Divine Garments Limited

Koyerpara, Chowgacha, Jessore.
(23.255206, 89.039256)
11th May, 2017

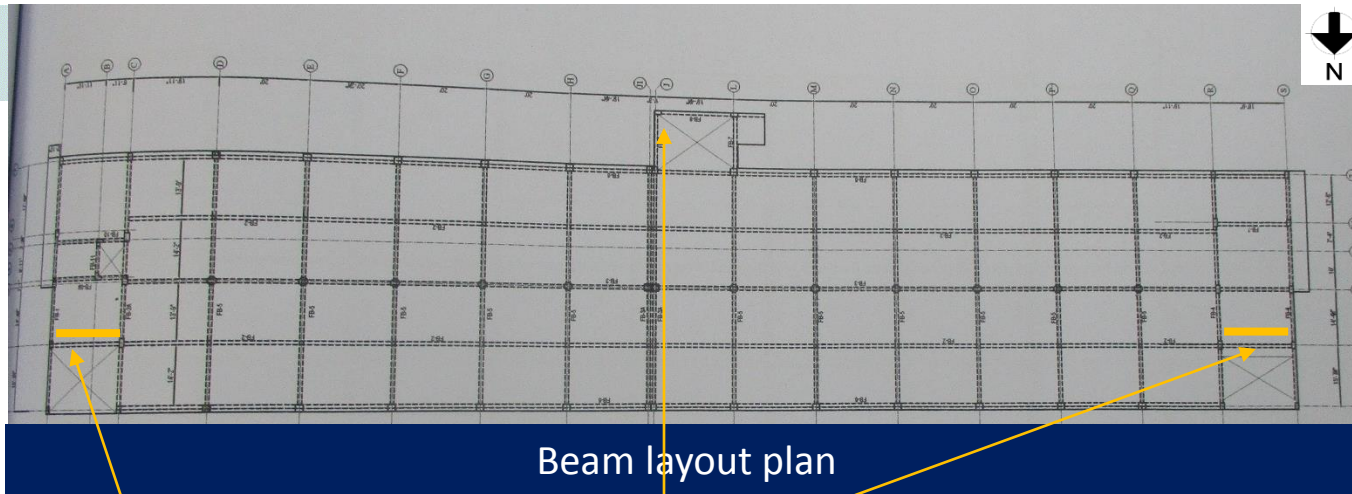
Inconsistency in beam layout of Garments Building

Beam shifted from drawings in yellow marked area.

Inconsistency observed between provided drawing and site observation. Factory engineer is required to survey the structure and update as built drawing..

Several beam sizes doesn't match with provided drawings.
